# ROAD SAFETY AUDIT

## PLYMOUTH ROAD

PROJECT OWNERS: CITY OF ANN ARBOR

DATE: OCTOBER 2025

Figure 24 - Right-in/Right-out Example<sup>3</sup>

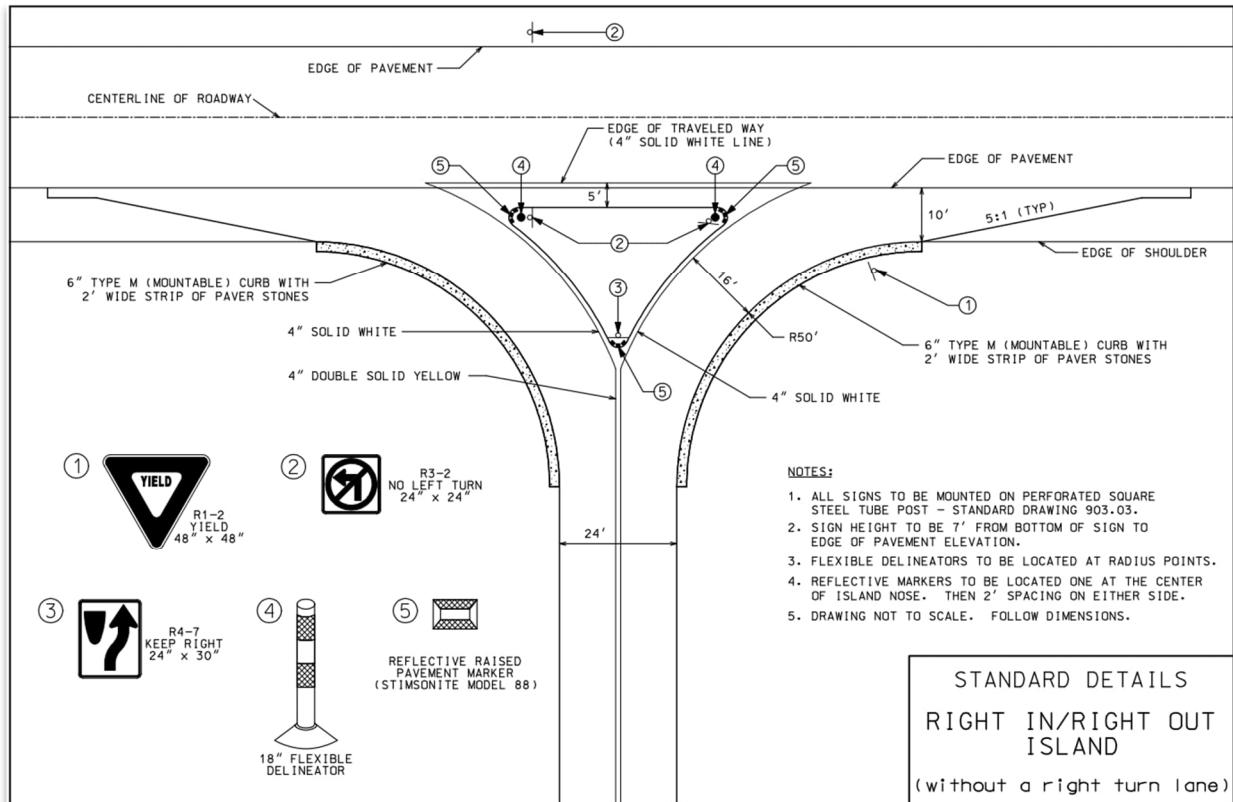
To decrease the risk of crashes resulting from left-turns and maintain efficient traffic operations along Plymouth Road and free space for a potential pedestrian refuge island, right-in/right-out driveway access should be considered for businesses along Plymouth Road. A right-in/right-out configuration which is shown in Figure 24, restricts left-turns out of driveways, reducing potential conflict points and the risk of severe crashes, while still allowing access to businesses. Importantly, all businesses along Plymouth Road have access from Green Road.

**Figure 28 - Lack of Corridor Lighting Along Plymouth Road, East of Southbound US-23 On-Off Intersection**

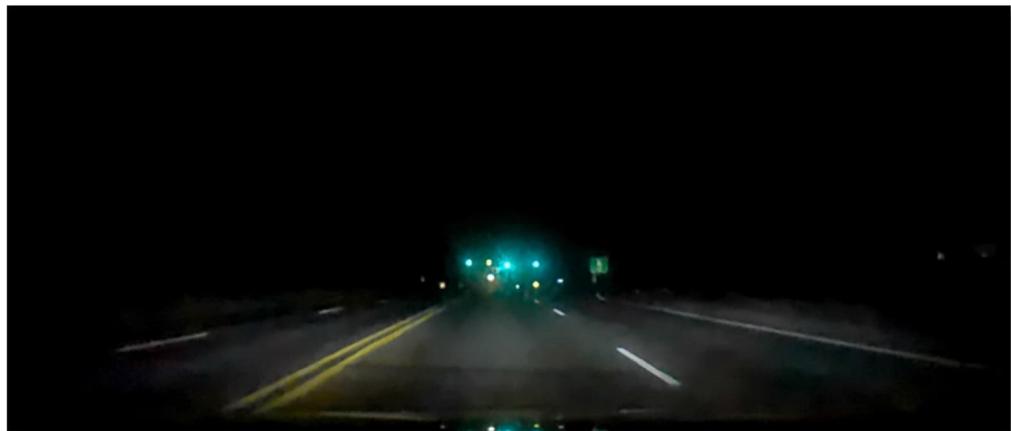
During the nighttime field review, the RSA team observed that there was no overhead or intersection lighting east of the Southbound US-23 On-Off Ramp intersection. The lack of lighting along Plymouth Road can be seen in Figure 28. This lack of lighting makes it more difficult for both motorists and pedestrians to see and be seen, increasing the potential for dark or low light condition crashes. Pedestrians, especially those who are visually impaired, may find it challenging to navigate safely in low-light conditions. Additionally, motorists may have difficulty identifying crosswalks, pedestrians, and other potential hazards, further exacerbating the need for adequate lighting. Having proper lighting in this area is essential for the safety and accessibility of all road users.

Consider installing overhead lighting east of the Southbound US-23 On-Off Ramp intersection, such as the lighting shown in Figure 29. Overhead lighting improves visibility during nighttime and adverse weather conditions, allowing drivers to see the road, signs, and potential hazards more clearly. This increased visibility can help reduce the potential for crashes by enabling drivers to react promptly to changing road conditions.

**Figure 32 - Illustration of the Alignment Shift at Southbound US-23 On-Off Ramp Intersection**

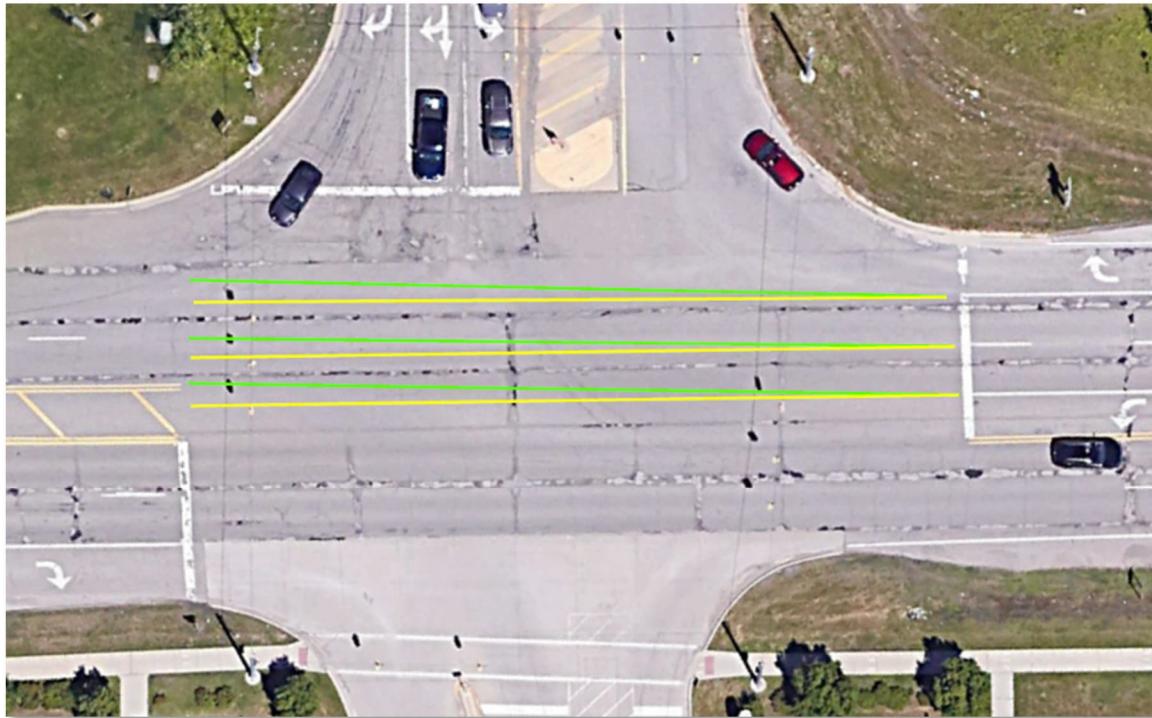
It was observed that there is a lane alignment shift through the westbound approach at the southbound US-23 On-Off ramp intersection, with the alignment shifting approximately 8 feet to the right. This shift could potentially create confusion for drivers, especially those unfamiliar with the area, leading to sudden lane changes or hesitation. Such actions can increase the likelihood of sideswipe same direction and rear end crashes and disrupt the smooth flow of traffic. Additionally, deteriorating pavement joints were observed in the roadway along the approach, which may be mistaken for pavement markings under inclement weather conditions or sun glare. Figure 32 below illustrates the alignment shift, with the yellow guidelines representing the alignment of the roadway if there was no shift and the green guidelines representing the transition of the lane lines along the roadway.

**Figure 37 - Plymouth Road Park and Ride Approach Concept<sup>6</sup>**

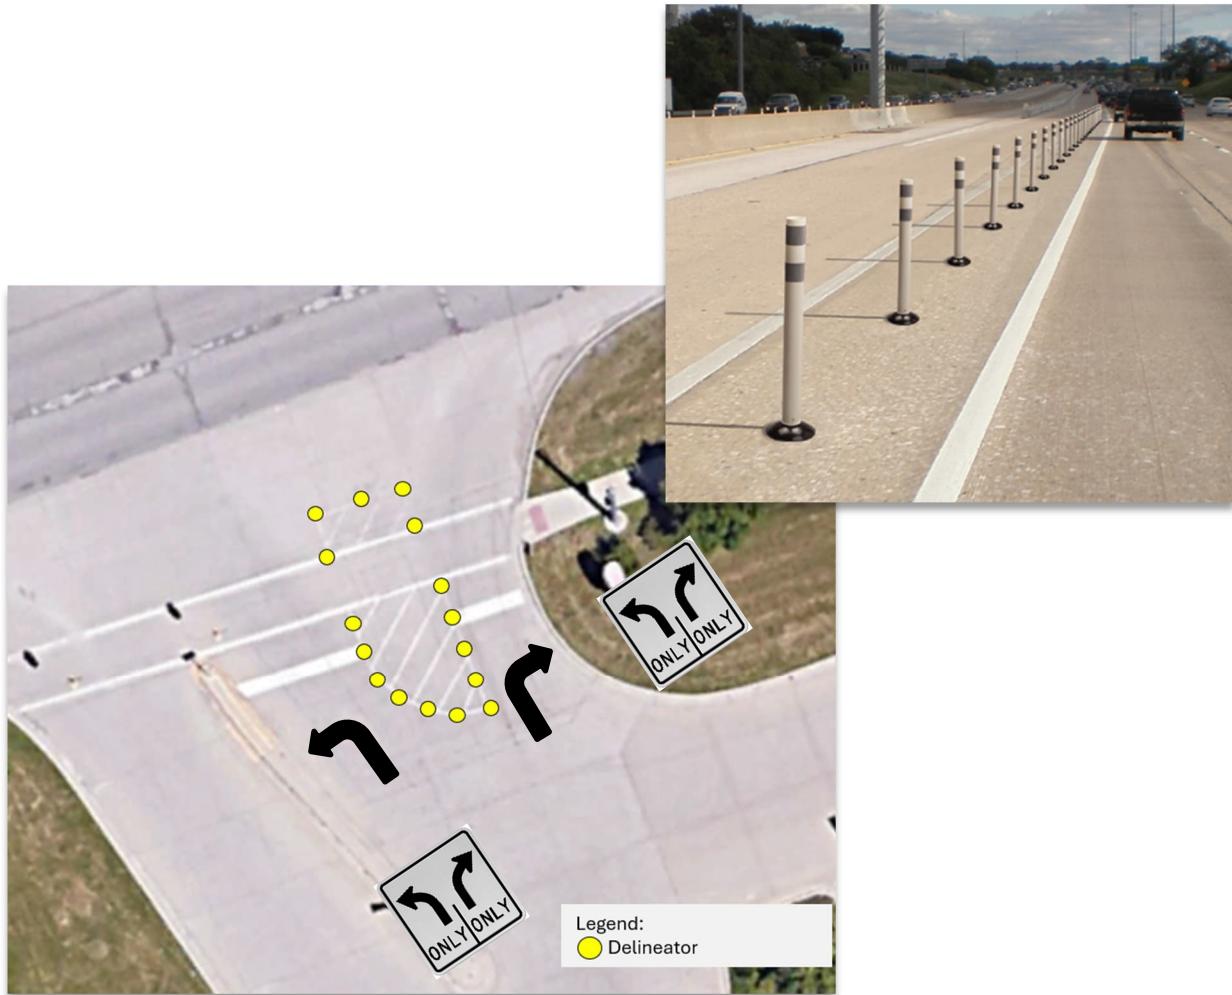
Furthermore, the stop bar at the Plymouth Road Park and Ride includes a gap to separate the left turn and right turn movements which is delineated by hatched pavement markings. This hatched area is significantly worn, resulting in a lack of clear delineation. Additionally, there is no signage to inform drivers of lane designation. This absence of distinct information can lead to confusion for drivers, potentially resulting in improper lane usage and increased potential for sideswipe crashes. Figure 36 depicts the gapped stop bar at the Park and Ride.

Consider adding delineators to the gapped stop bar, as well as adding arrow pavement markings and lane use signage on the approach. These improvements may enhance safety by providing clear and visible guidance to drivers, reducing confusion and the potential for crashes. Refreshed hatched markings and delineators will clearly indicate the separation of lanes, helping drivers follow the correct paths. Updated arrow markings and lane use signage will provide clear instructions on lane usage, reducing the likelihood of improper lane changes.
